**Memorandum:
Fairway Estates Phase II PUD/Subdivision Application**

Date: 09/22/2022
To: City of Florence, Planning Department
From: Metro Planning, Inc.
Subject: Completeness Comments for PC 21 39 SUB 03 & PC 21 40 PUD 02

Subdivision Name: Fairway Estates Phase 2
Map/Lot: 18-12-15-00, TL 1500
Site Address: Florence Oregon 97439

Map 1- Open Space and Parkway Areas, please see attached plan linked below.

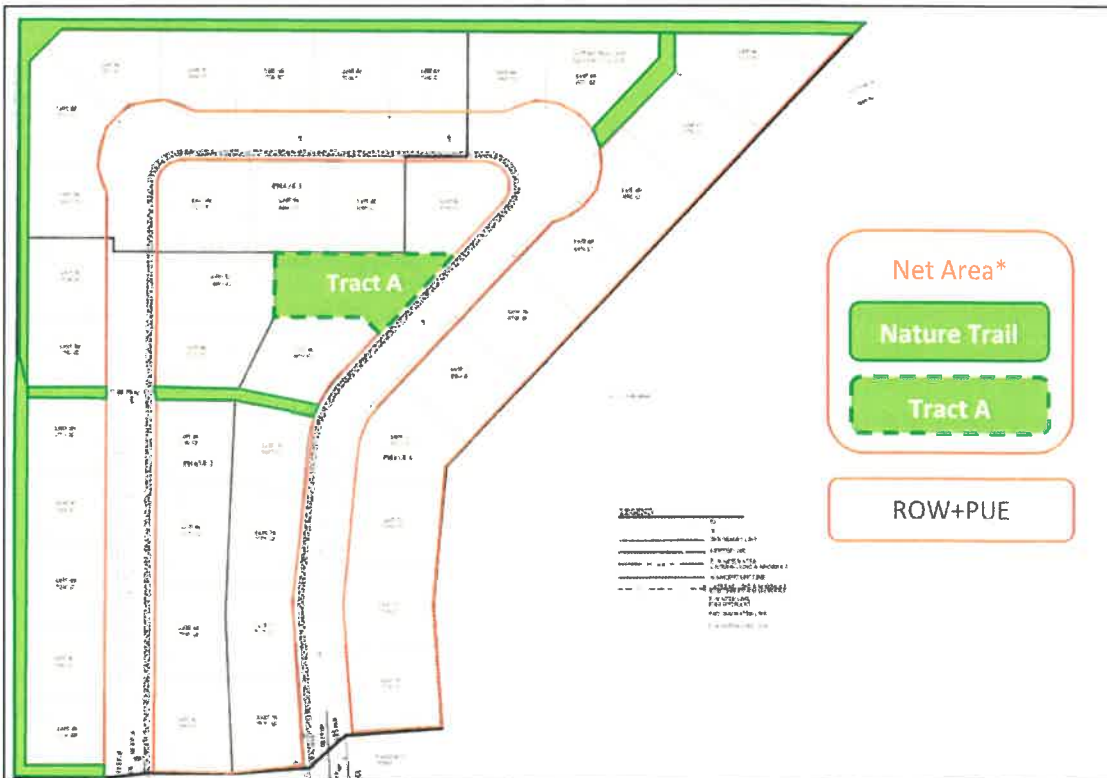
- ***PUD: Open Space and Recreation Plan (10-23-5-E: location, design, percentage of development area)***

Response: Please see table below for Open Space (and Parkland) area breakdown.

Table above lists proposed Open Space by percent of Net Area. Net Area is the overall site area (extending to the plat boundary) minus the sum of public utility easement (PUE) and right-of-way (ROW) areas. Please see illustration below.

Map 2 - Nature Trail Connection, Revised Utility Map⁴

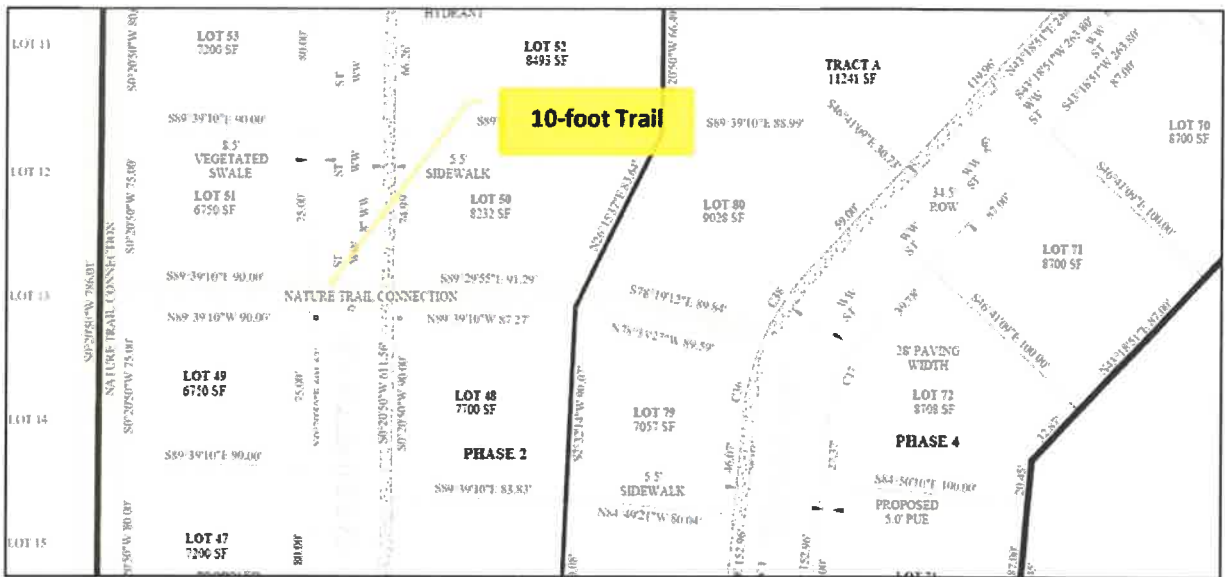
Response: Applicant seeks exception to Block Length and Block Perimeter requirements as the shape of the site and the lack of connecting streets on adjacent properties make it impracticable to conform with FCC 10.36-2-10. (Please see written statements below under FCC 11-7 that address exception/modification criteria.)

In support of the purpose of FCC 10-36-2-10, applicant proposes a nature trail near the middle of a block in-lieu-of a street connection and also seeks Planning Commission consideration with a request for exception/modification to block length requirement. (Please see written statements below under FCC 11-7 that address exception/modification criteria.)

Please see attached Plans for more detail³. Please see illustrations of Nature Trail Connection on Revised Utility Map below.
